ADDENDUM

No. 03 Date: 9/11/2024
Project No. 0020711.01 Attention: Leonard D'Souza
Project Name: Princess Margaret Cancer Centre
Stem Cell Transplant 2, MHC, MHDU, DSC
Address: University Health Network
610 University Avenue
Toronto ON

This Addendum forms a part of the Bidding and Contract Documents and modifies the original issued Bidding Documents (dated August 13, 2024) for the above titled project, as indicated below, and is hereby incorporated into the Contract Documents as part thereof.

3 LEVEL 04 CONSTRUCTION CONTROL PLAN
1:300

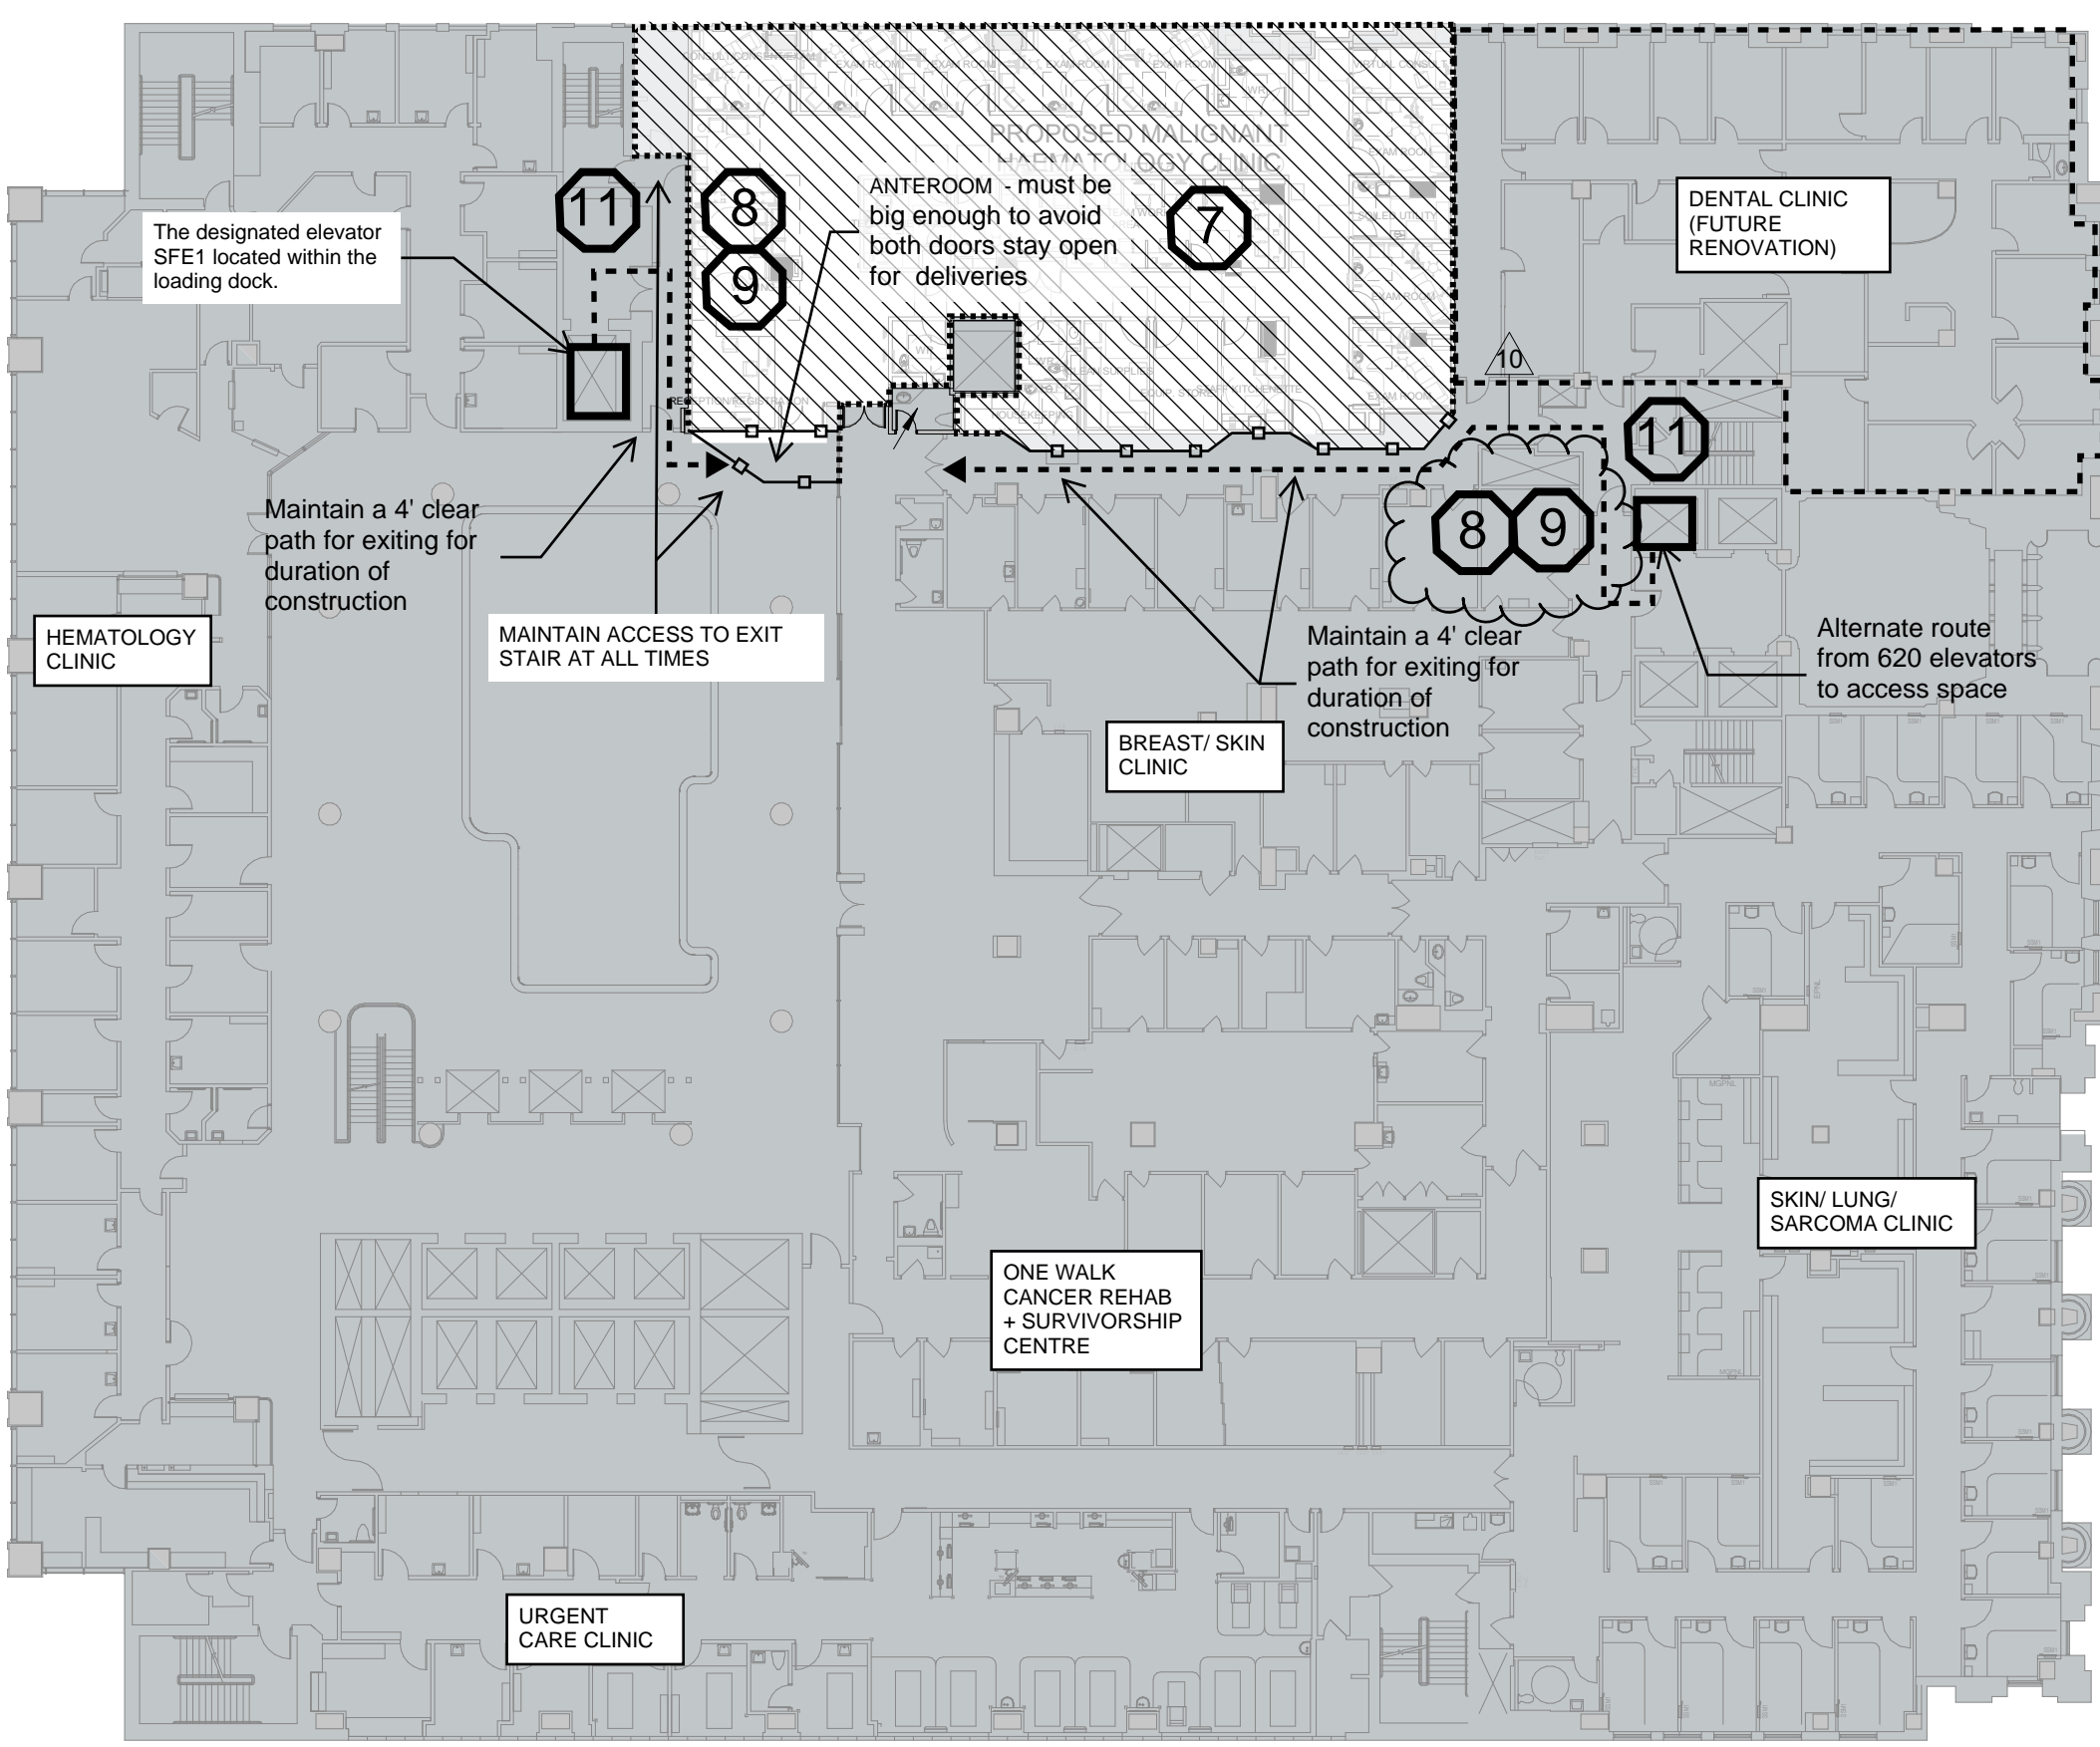
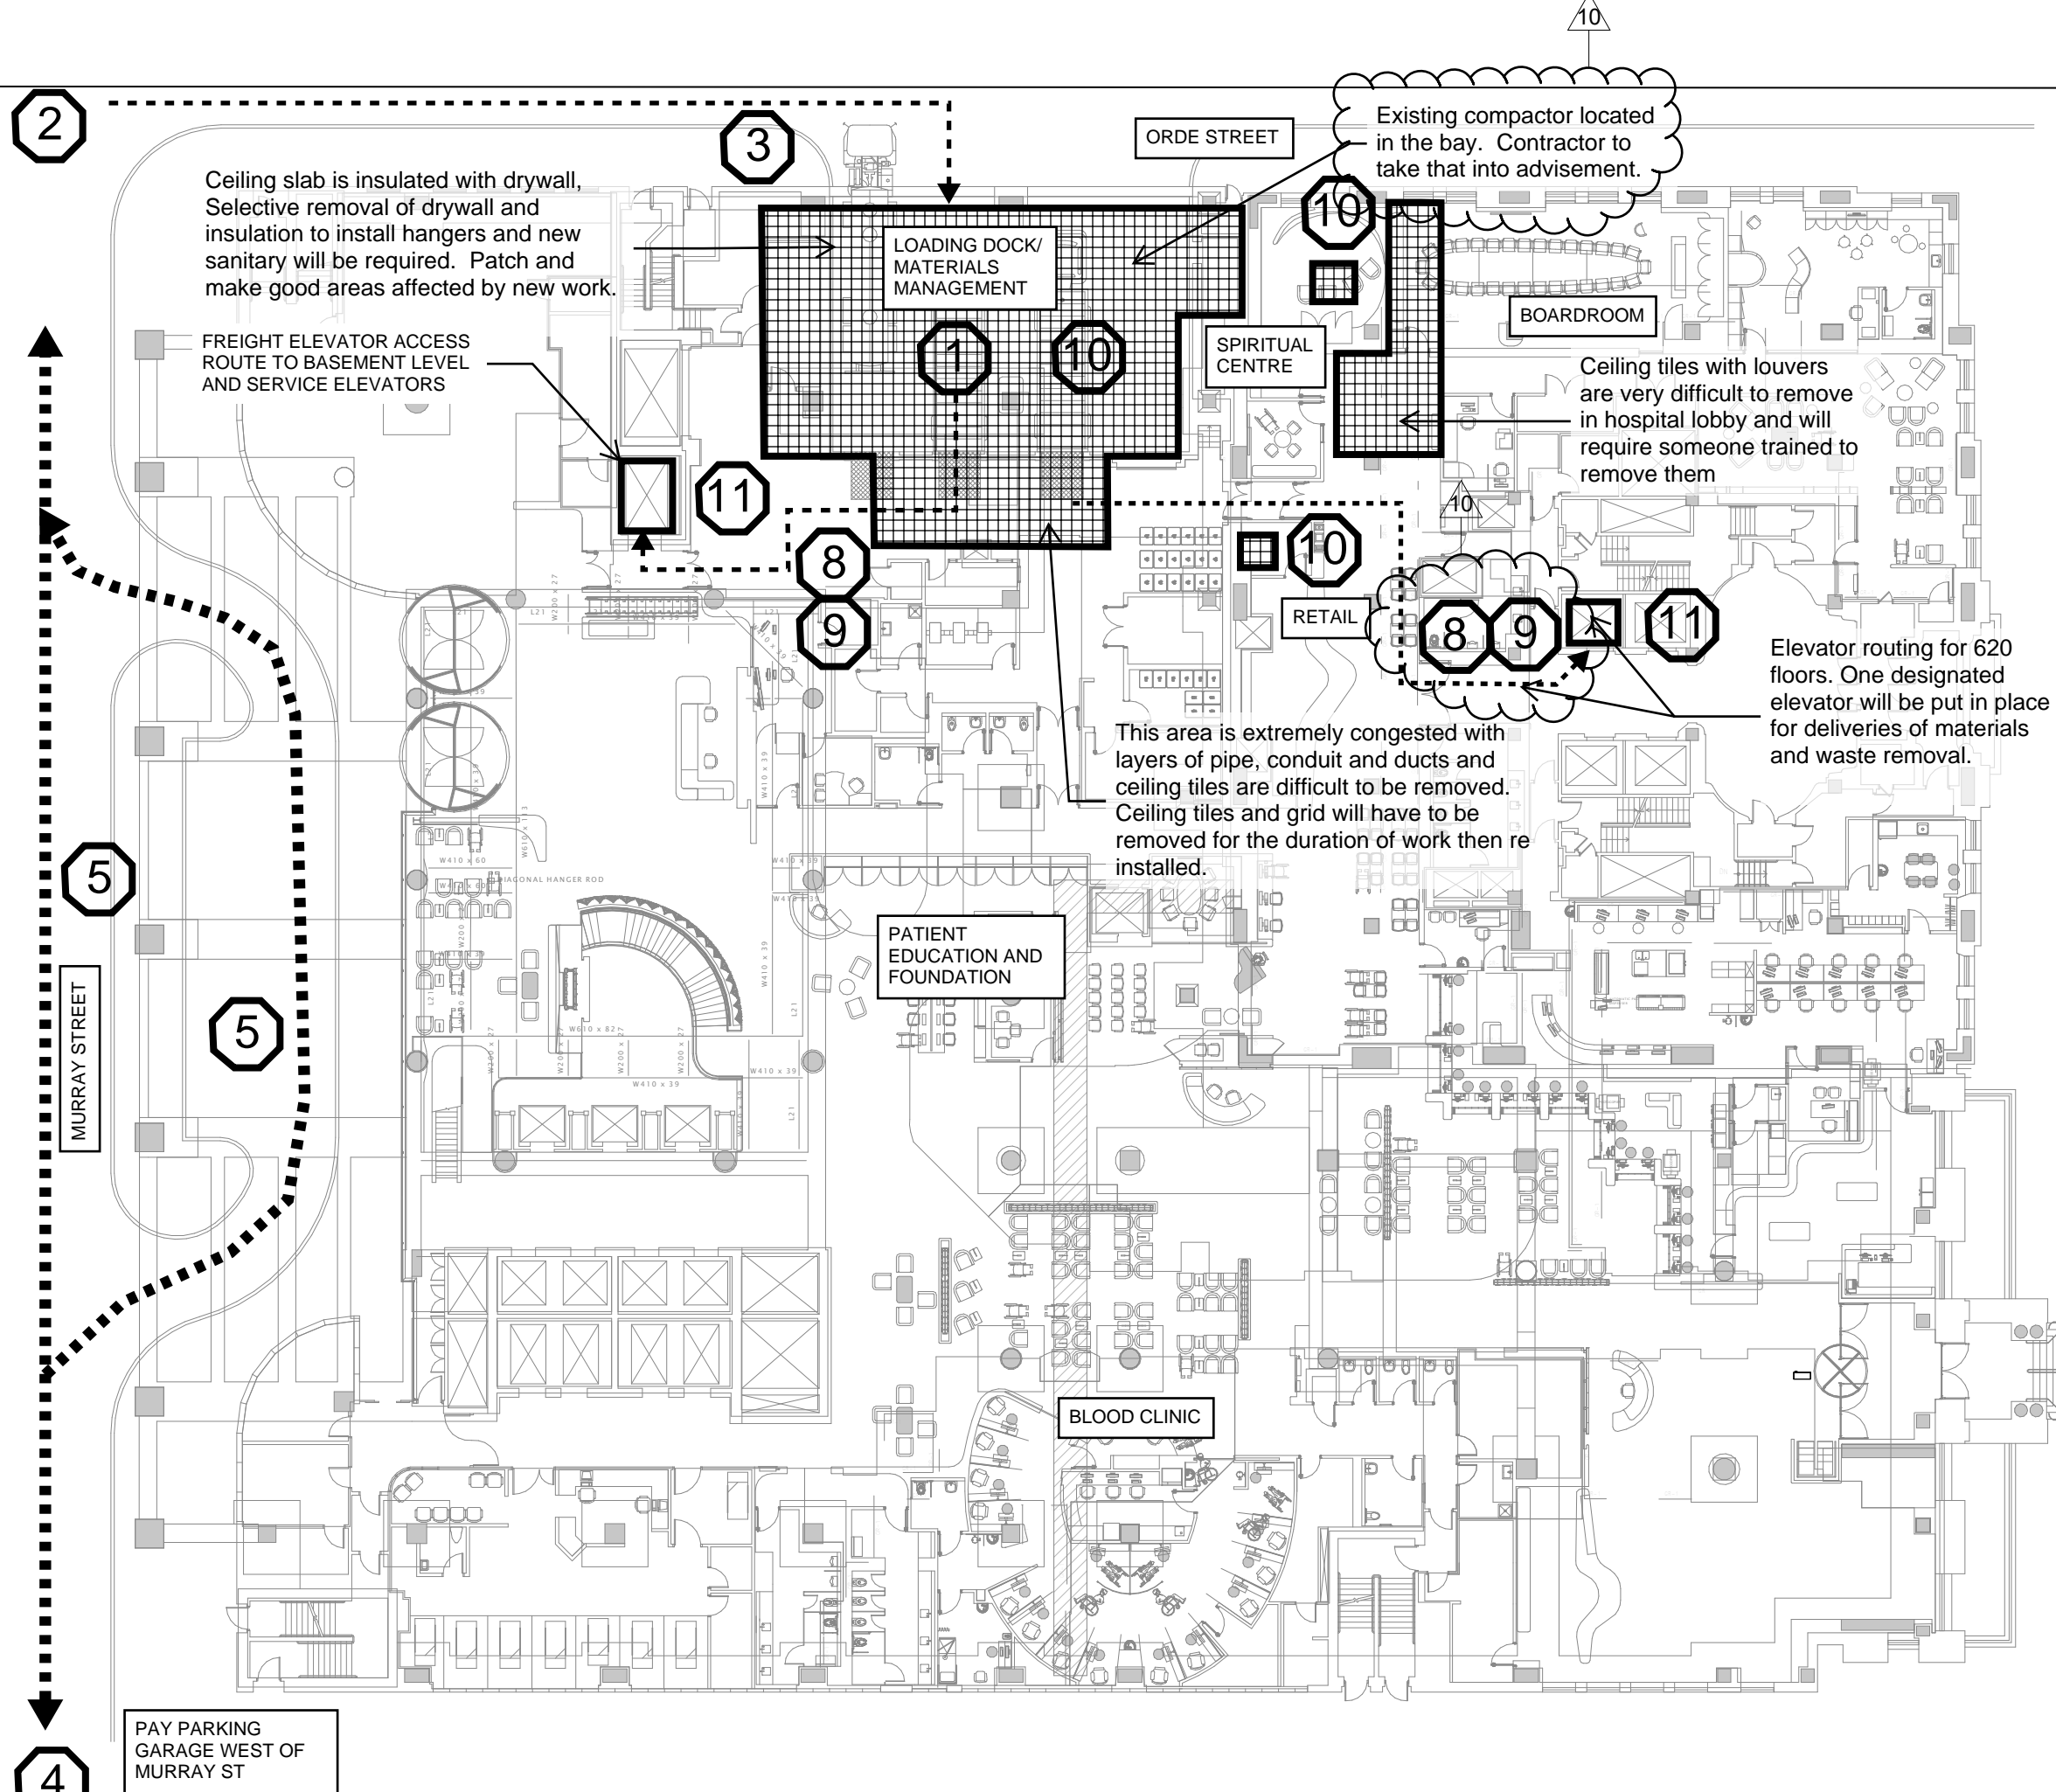
DRAWING G0501 – CONSTRUCTION CONTROL PLANS

Revised legend, added notes for travel paths, exit stairs, compactor in loading, added hoarding for phased construction on Level 5 MHDU.
